PRIVATE WATER DISTRIBUTION SYSTEM IMPROVEMENTS
TO SERVE
AIRXCEL WAREHOUSE ADDITION

PROJECT NO. 2022-019568PPW

AS BUILT

PRIVATE WATER DISTRIBUTION PLANS FOR
AIRXCEL WAREHOUSE ADDITION
3050 N. ST. FRANCIS STREET, WICHITA, KANSAS 67219

PHASE 2 SCOPE OF WORK

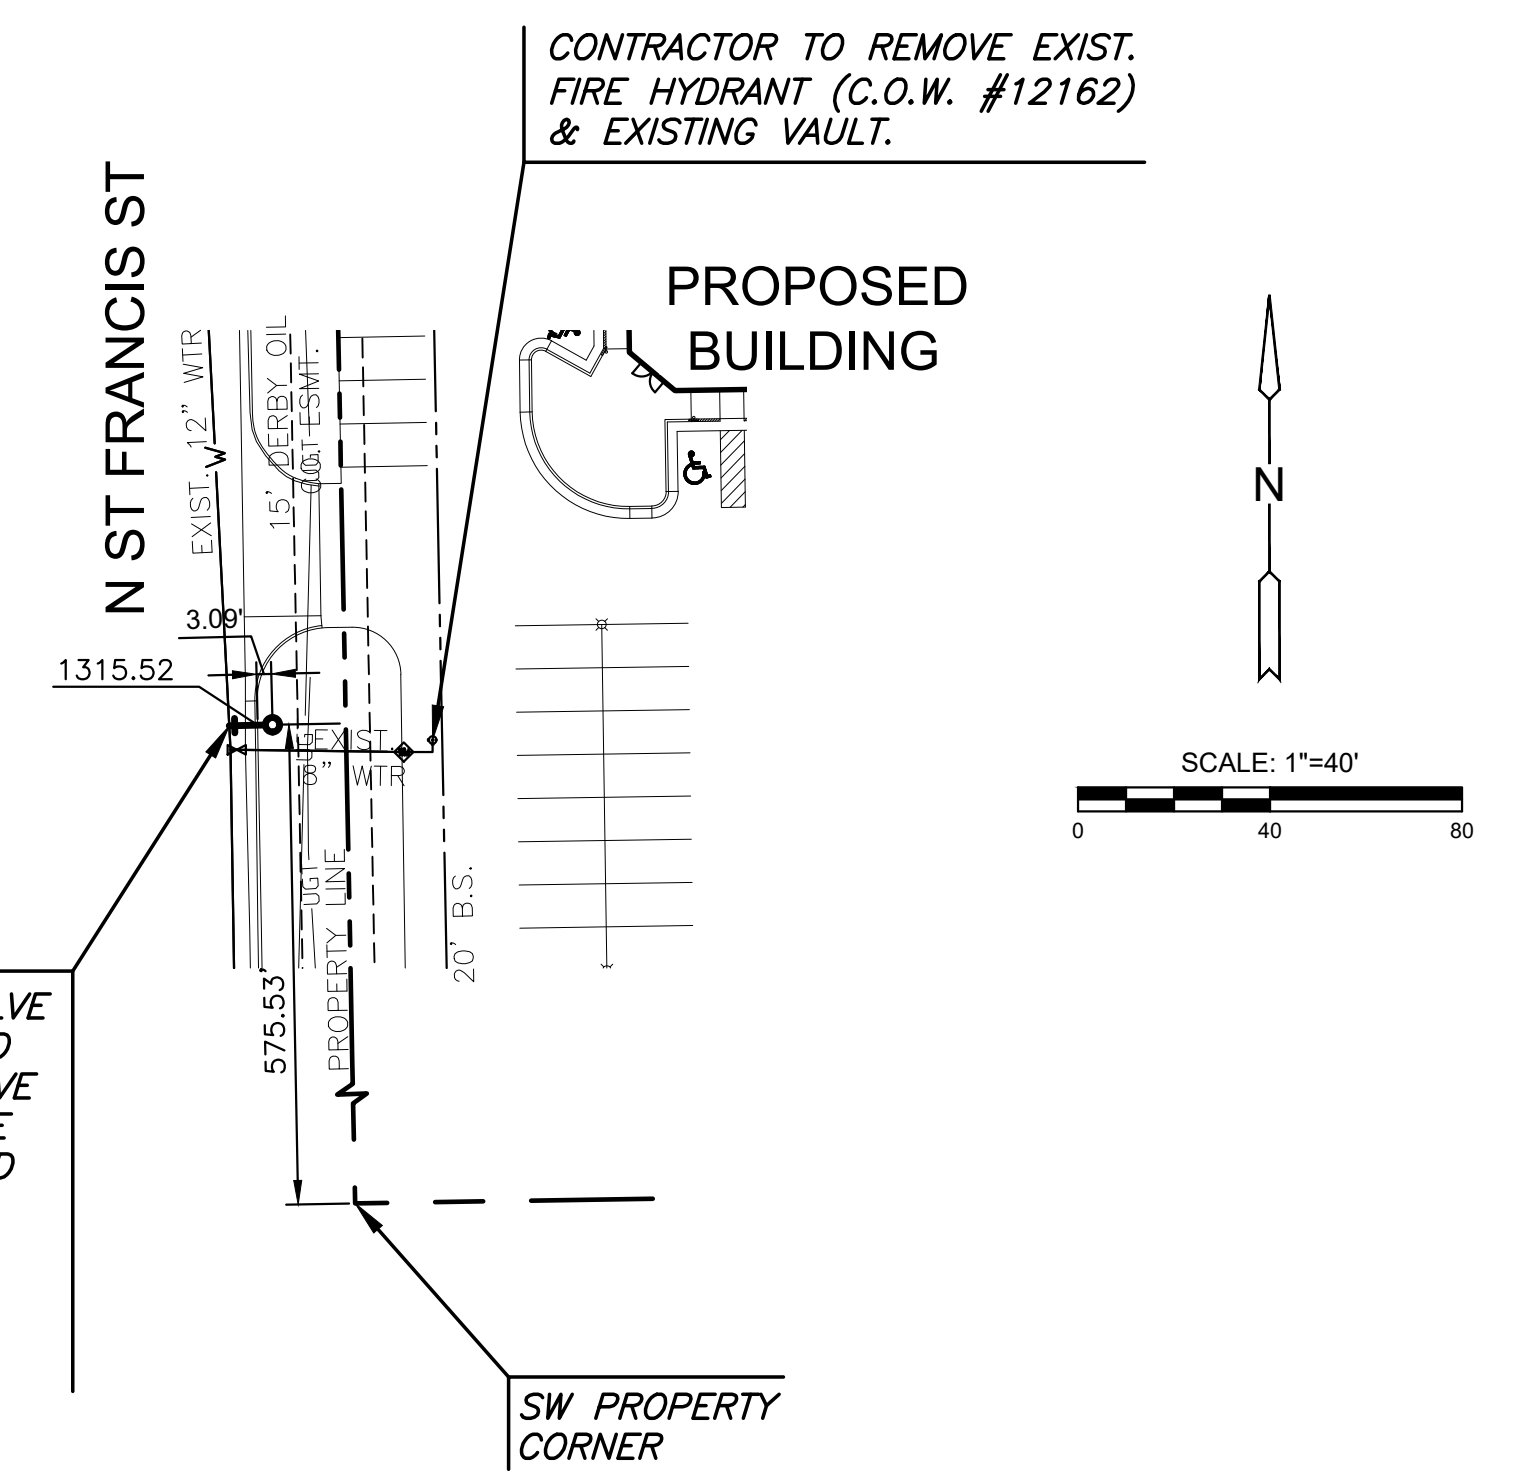
Not constructed in this phase by McCullough. This FH will be install
by a different contractor on PH2.
